#3029945-LU

514-524 FEDERAL AVE E RECOMMENDATION
SHW

514-524 FEDERAL AVE E
SDCI# 3029945-LU

A SECTION - NORTHEAST NEIGHBOR

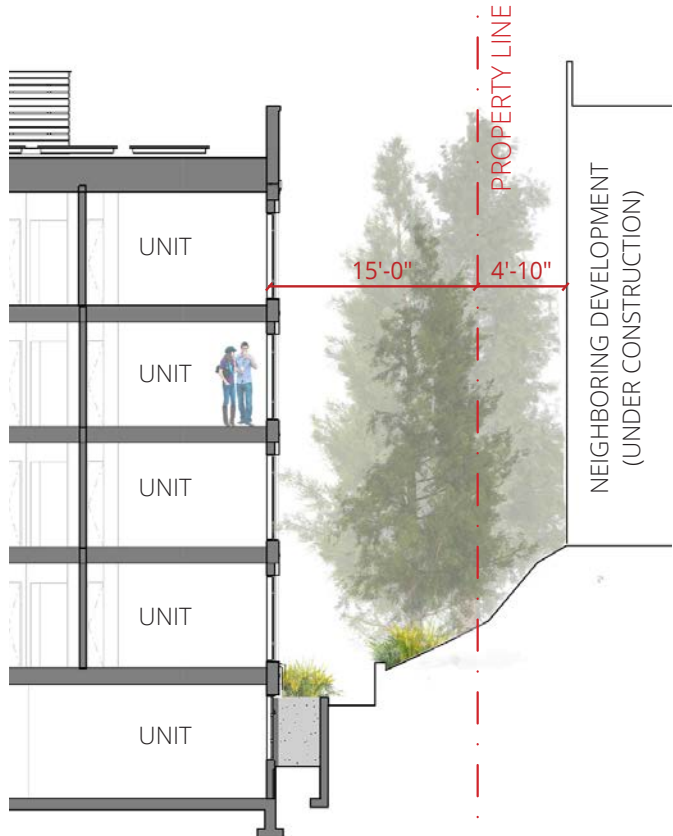
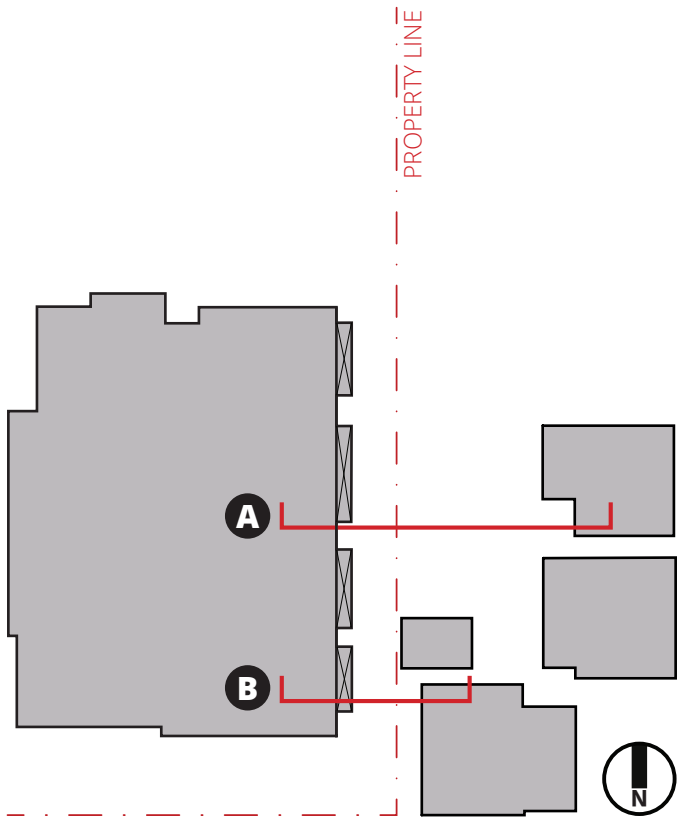
The Board asked for privacy studies at interior lot lines, and for complete site plan and landscape details that show how plantings (particularly trees) will provide buffers at the edges shared with the park and with other residential uses.

Trees, both existing and proposed are a significant consideration in this proposal. The street tree canopy will remain a defining characteristic of the block. All mature trees along the rear setback are being retained creating a significant buffer to the east. New trees are proposed along the park edge, at the building entry and along the street-facing units. See **PAGE 18** for park relationship, **PAGE 23** for residential edge development and **PAGES 24-25** for landscaping.

- All existing, mature trees are being retained along the east property line. *CS2.A1: SITE CHARACTERISTICS*
- Integrated new low-level plantings to further enhance the experience for window well units without blocking light. *CS1.B: SUNLIGHT & NATURAL VENTILATION*
- As suggested at EDG , balconies or decks are not provided at the east side of the building to limit outside activity and noise facing residential neighbors. *CS2.D5: RESPECT FOR ADJACENT SITES*
